Closing Open ERL Items

D. Beavis

July 16, 2104

ERL Roof

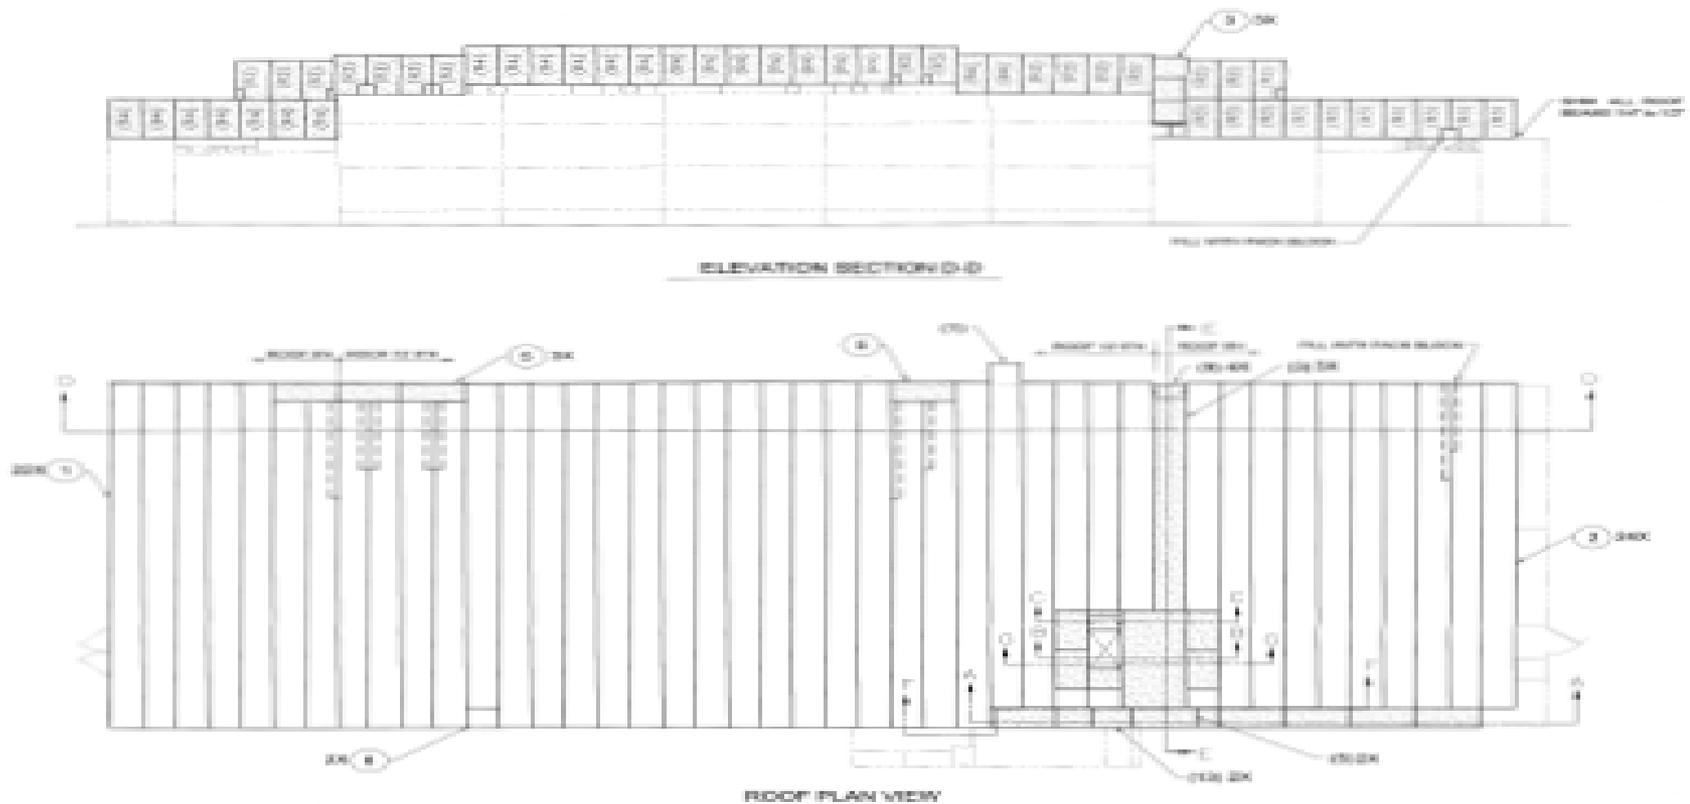
- ATS Work permits for all roof work
 - ERL roof posted
 - All access points to bldg 912 roof being posted
 - I have suggested that all access points be fenced and locked with a key issued after work planning complete.
- Update dose for one MW waveguide port
 - July 14, 2014 memo
 - 50 mrad for 3.5 MeV beam loss at a beam power of 1 MW
- Established an ATS item for comprehensive set of beam fault studies and review. Closed individual items in database and ATS
- **CONCLUDE items from 6/25/14 meeting are ready for ARR**

East wall looking from outside

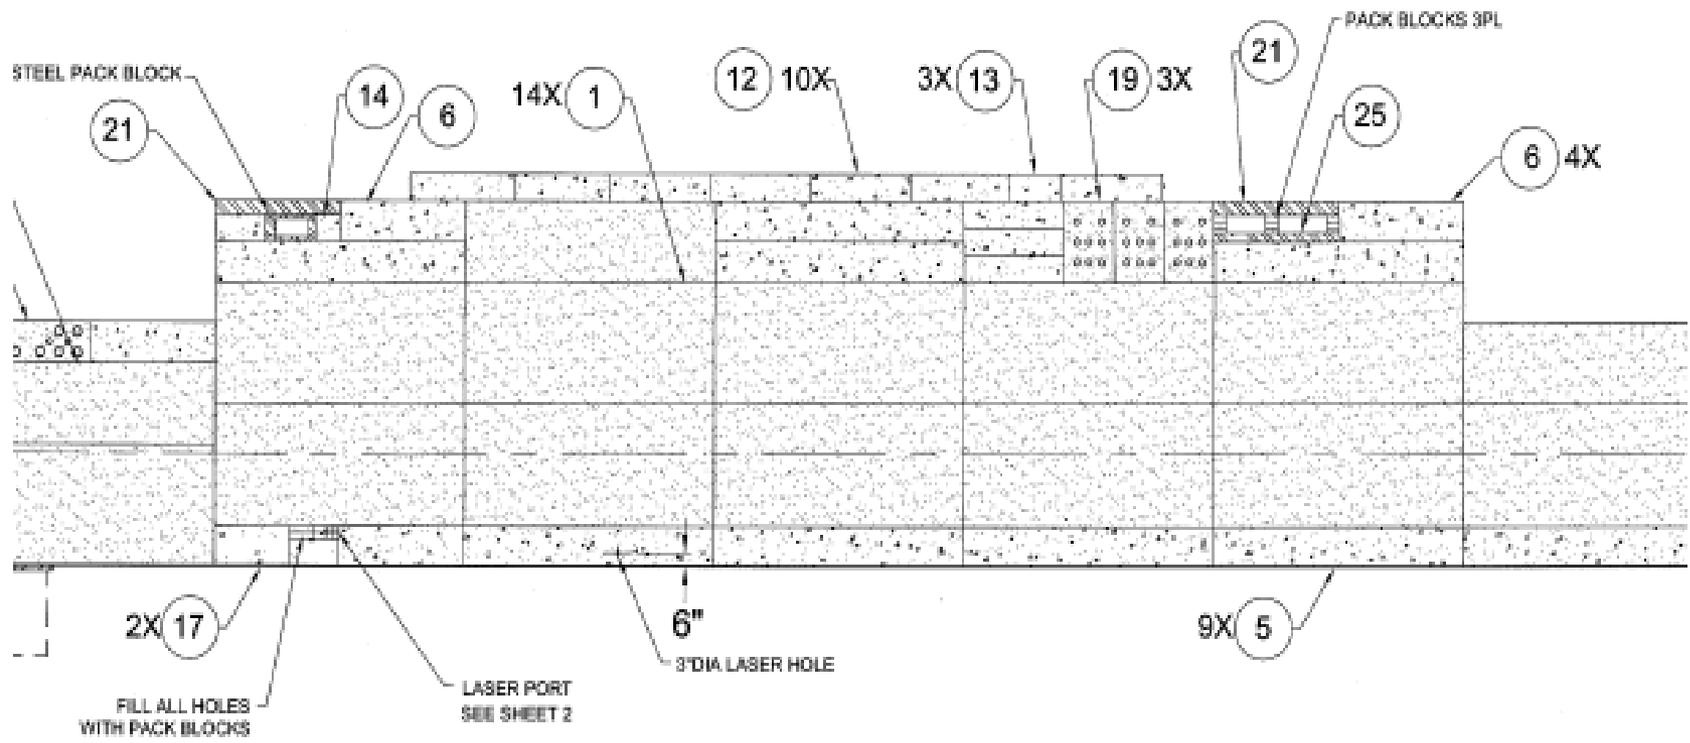
Vertical seams on side walls

- Requested that the vertical seams have four inches of Pb for the ones that can have brems losses directly across.
- There are additional vertical seams high
 - Some not much of an issue
 - Others on wall for second floor of the condo (utility building) More a problem for ring. Only a small section of low energy transport is an issue
